RECEIPT DATE: 2-8-18 **ONSITE SEWAGE DISPOSAL SYSTEM** P 562422-A

PROPERTY ADDRESS: 1011 Fairlane Road

SUBDIVISION: Fairlane Farms LOT: 15 TAX ID: _____

From: Collins, Sarah
Sent: Thursday, March 01, 2018 9:19 AM
To: Tony Fertitta (tonyf@fcc-eng.com)
Cc: Bernard, Dana
Subject: Fairlane Farms lot 15 septic plan

SEPTIC PROFILE
SCALE: 1" = 30'

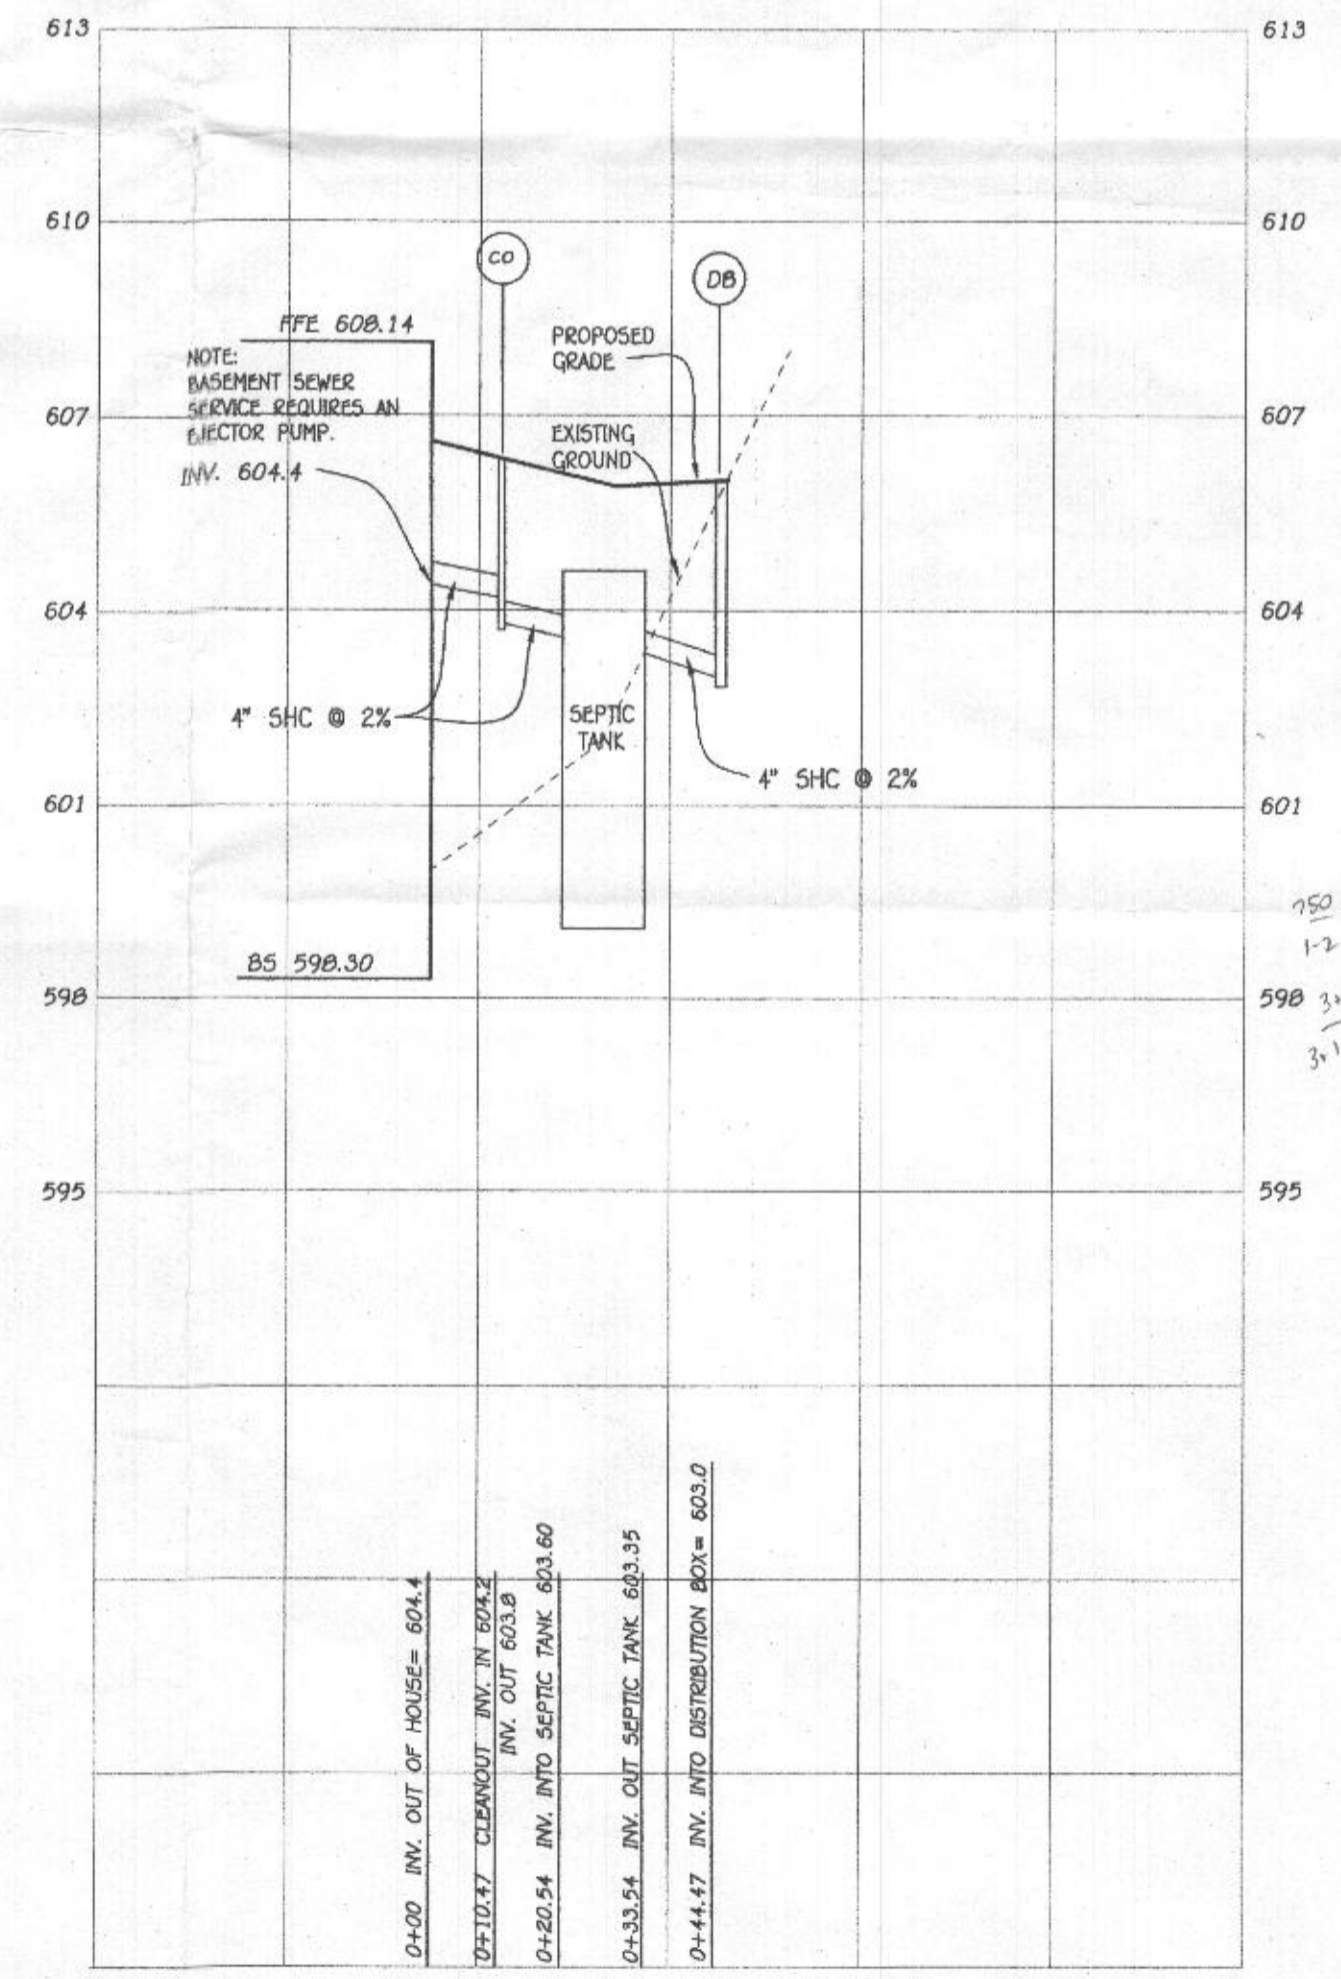
2/28/18 Met S. Carroll on site for layout. SDA corners staked, pipe out of house at location shown on plan, ~10' farther from porch/downhill. Shot elevations: bottom of pipe @ house = 82.5"; grade at tank inlet = 58"; grade at T1 inlet = 13". Line will not make 3' inlet at trenches. Will contact engineer to revise plans. (SC) 3/6/18 Swale filled in between house + SDA, sewer line can come up to within 30" of top of foundation wall. Shot elevations and will make 3' inlet at T1 with minimal

I met South Carroll on site at lot 15 at Fairlane Farms to layout the septic system yesterday. We shot elevations and determined that the line from the house will not make fall to a 3' inlet at the upper trench.

Here are the relative elevations that we shot:
Bottom of the sewer line at the house = 82.5"
Grade at the tank inlet = 58"
Grade at the upper trench start = 13"

The sewer line is coming out of the house on the same wall as shown on the plan, maybe ~10' farther away from the porch. The line could be at a lower elevation than shown on the plan.

Let me know if you have any questions. Please get in touch with Dana regarding plan revisions.
